**Report:** TES-DCS-16-12.1

## **Region of Waterloo**

**Subject:** **Class Environmental Assessment Study**  
**Bridgeport Road/Caroline Street from King Street to Erb Street and Erb Street from King Street to Caroline Street, City of Waterloo**

### Public Comments Received from the January 27, 2016

# ERB STREET (CAROLINE STREET TO KING STREET) PREFERRED DESIGN CONCEPT

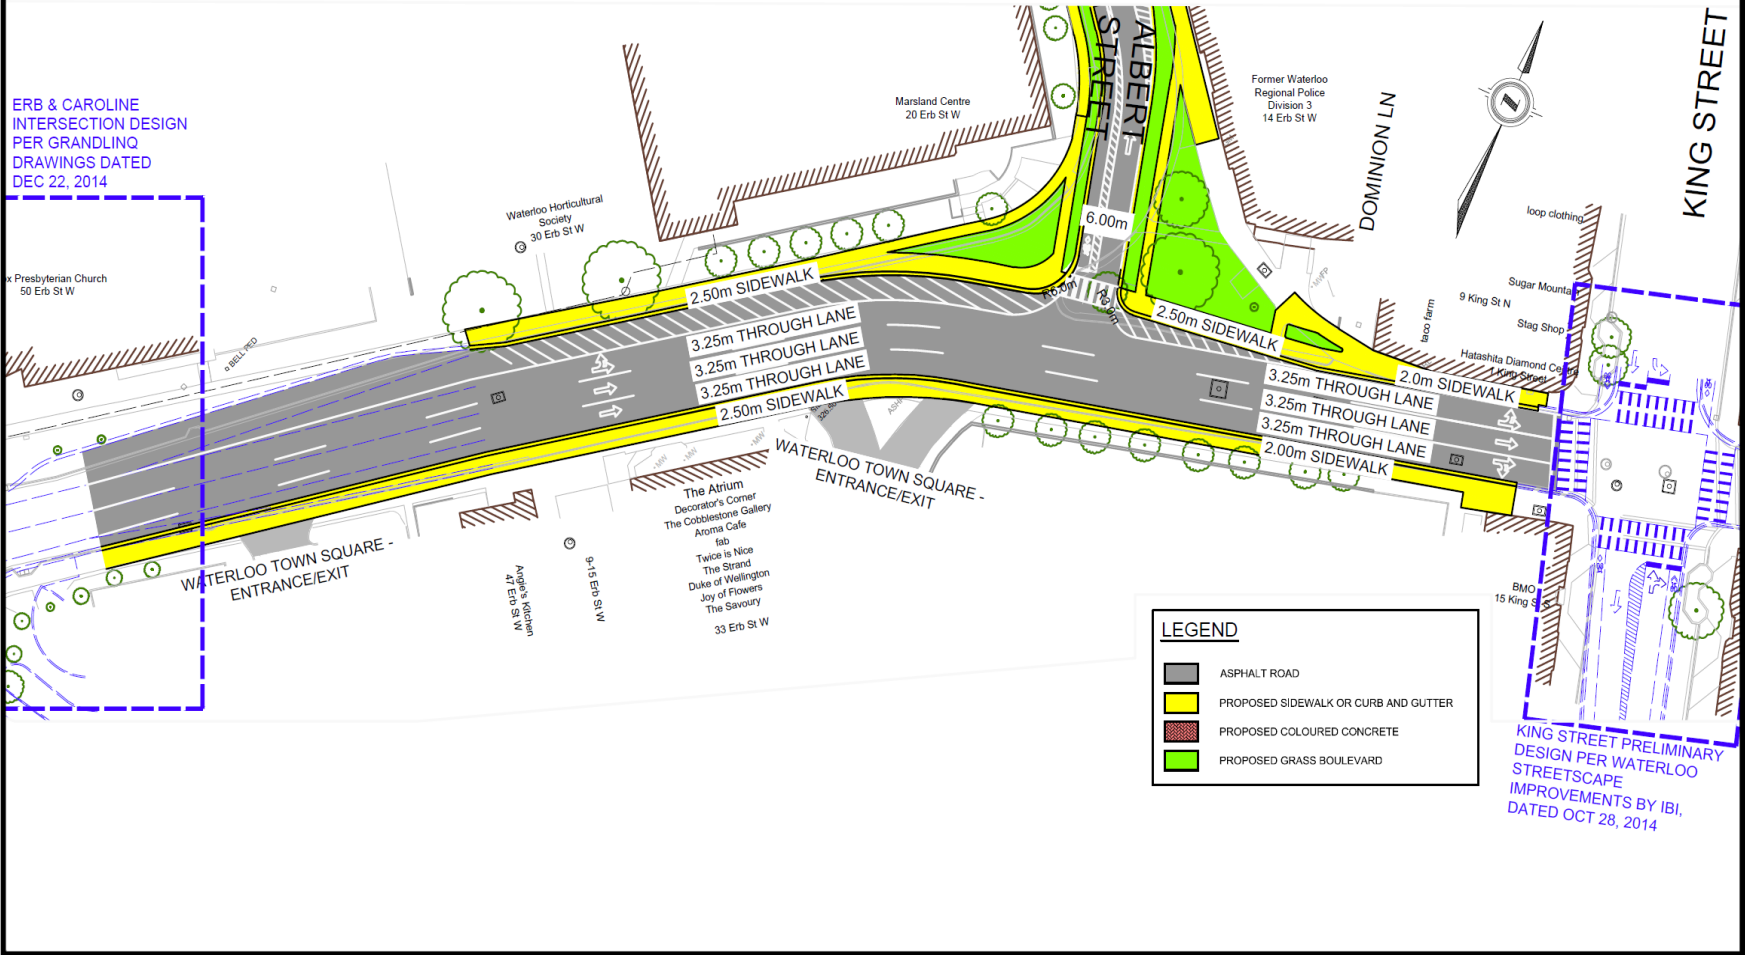
Erb should not be made three lanes with a sharrow lane, as planned; Some other way to maintain options in case a two-way cycle track on Erb between Caroline and Margaret is approved should be pursued.

A boulevard should be provided on Erb Street (perhaps if it turns out that Erb will have a cycle track). Having to walk directly adjacent to vehicle traffic lanes make for an extremely hostile experience, and not including a boulevard along Erb will mean foot traffic will be diminished.

Erb St: Needs improvement, sharrows are inappropriate here. The shoulder is unnecessary. TriTAG's proposed design is a big improvement and I recommend using it. Removing the shoulder, adding a crossing, and making the right lane a turning only lane I believe are substantial improvements. My modifications would be to move the crossing back so that it occurs at the dividing island, and thus only requires pedestrians to cross 2 lanes, and to narrow the lane with sharrows to only 3 m wide.

Sharrows are totally inappropriate in this application

The sharrows proposed for Erb St are inappropriate. Sharrows work on low speed roads, not major high-speed multi-lane arteries. Sharrows are not a replacement for dedicated cycling infrastructure, and 2016 should be the year we stop pretending they are.

The width of Erb St is drastically wider than the planned use. There is no need for 3 through lanes and a painted shoulder lane. Staff mention a potential possibility for on-road cycle tracks, "without the need for additional construction," but it would require waiting for "a separate, broader study to consider implementation of a two-way cycle track on Erb Street from Caroline Street to Margaret Avenue [which] will be completed by the Region of Waterloo in the future." In the meantime, Erb will remain gratuitously wide. A pedestrian crossing at Erb/Albert is dismissed, because there are fewer than

I am not in support of implementing sharrows on Erb. While this was explained as a temporary measure until another study can be complete, I believe that this would be a misapplication of sharrows on a high volume road.

Sharrows are green, on-road paint markings advising motorists that a travel lane is to be shared between vehicles and cyclists. The sharrows identified on the plans presented at the January 26, 2016 PCC on Erb Street from Caroline Street to King Street were proposed as an interim solution to provide a shared-use lane for vehicles and cyclists. However, upon further review of the comments received from the public and Advisory Committees, the Project Team has eliminated the sharrows on Erb Street from Caroline Street to King Street in the Recommended Design Concept.
